**BEFORE THE HEARINGS PANEL
FOR THE PROPOSED QUEENSTOWN LAKES DISTRICT PLAN**

IN THE MATTER of Hearing Stream 14:
Wakatipu Basin hearing
and transferred Stage 1
submissions related to
Arrowtown and Lake
Hayes

**STATEMENT OF EVIDENCE OF HELEN JULIET MELLSOP
ON BEHALF OF QUEENSTOWN LAKES DISTRICT COUNCIL**

LANDSCAPE

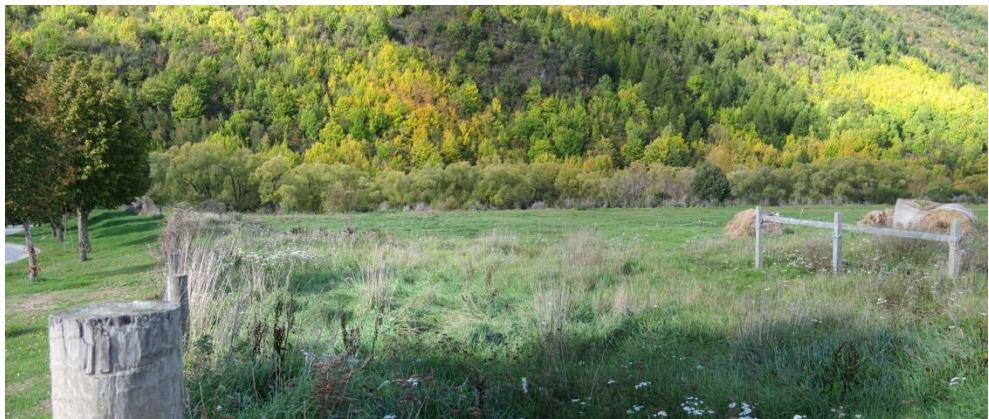
- 7.57** In terms of effects on visual amenity only I consider that a narrow strip of LDR development could be absorbed on the western side of McDonnell opposite existing development if it was effectively screened from Arrowtown - Lake Hayes Road and did not impact on the open pastoral nature and remaining rural character of the approach to Arrowtown. However from the wider perspective of the landscape character of this part of the Wakatipu Basin, I consider the LDR zoning

would not be appropriate. It would breach the current containment of Arrowtown's urban form by McDonnell Road and in my view could provide a precedent for further inappropriate spread of development into the rural land west of the road. I disagree with the submitter's statement in paragraph 5.9 of the submission that '*the subject site is topographically distinct from the adjoining land to the south*'. While the parts of the site adjoining Arrowtown - Lake Hayes Road and the northern part of McDonnell Road are predominantly flat, the remainder of the site has the same underlying glacial till geology and the same undulating topography as The Hills golf course to the south.

- 7.58** In my view the proposed landscape protection set back of 25 metres on Arrowtown - Lake Hayes Road would not be sufficient to maintain the valued visual amenity and spaciousness of this approach to Arrowtown, which is an important scenic route. The strip of LDR development and the five rural residential properties enabled by the structure plan are likely to be visible from the road and would be perceived as a spread of development from urban Arrowtown into its rural surrounds. If screening vegetation was implemented this would also likely obstruct views from the road to the Crown Escarpment and Crown Range.
- 7.59** Consequently I oppose the LDR zoning and structure plan sought by Submitter #2397.

Figure 14:: Arrowsouth South Structure Plan annotated to show relationship with LDR rezoning sought by Submitter #2299.

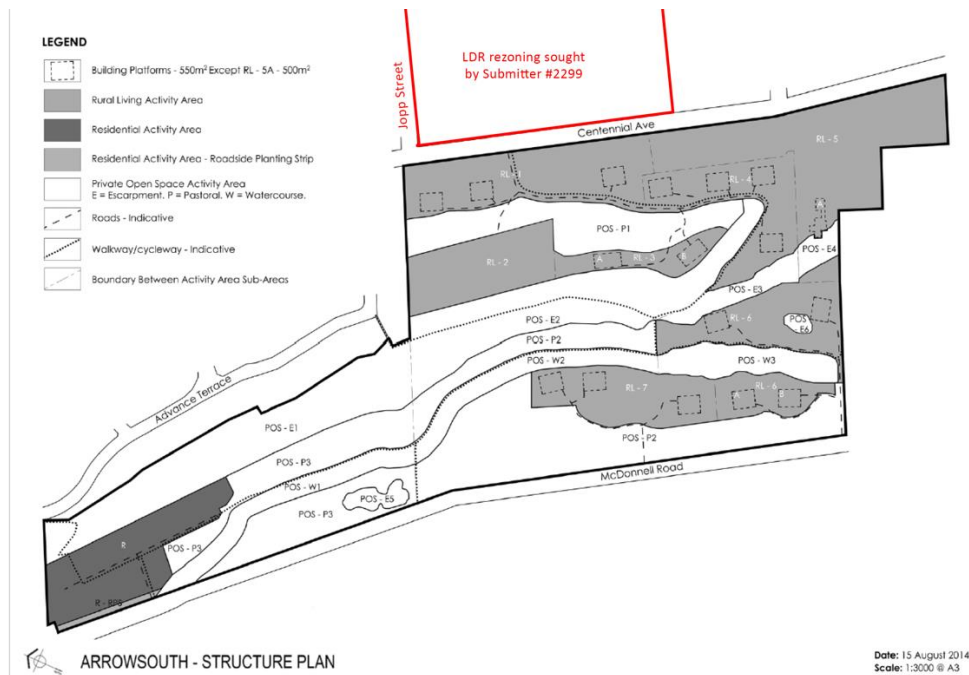
7.62 In my assessment, the LDR zoning sought could be absorbed within the landscape without significant adverse effects as long as an appropriate building setback was maintained along Centennial Avenue. The proposed LDR area is within the same landform as existing low density development within the Arrowsouth UGB and does not breach any of the topographical or other boundaries that define the settlement. Urban development within the land would be visible from the margins of the Arrow River, but I consider it would be perceived as a logical extension of urban form and would not significantly detract from the visual amenity of users or the natural character of the river margins.

7.63 The Centennial Avenue interface is more sensitive. There is currently a clearly defined hard edge to urban Arrowsouth at the Jopp Street intersection and anticipated development in the Arrowsouth South Zone west of the road is intended to be rural in character and to maintain a level of openness adjacent to the road. Trees in the road reserve on the eastern side of Centennial Avenue do however currently obscure most views of the golf course. I consider there is potential for the amenity of this entry to Arrowsouth to be maintained by additional planting combined with a building setback of at least 20 metres.
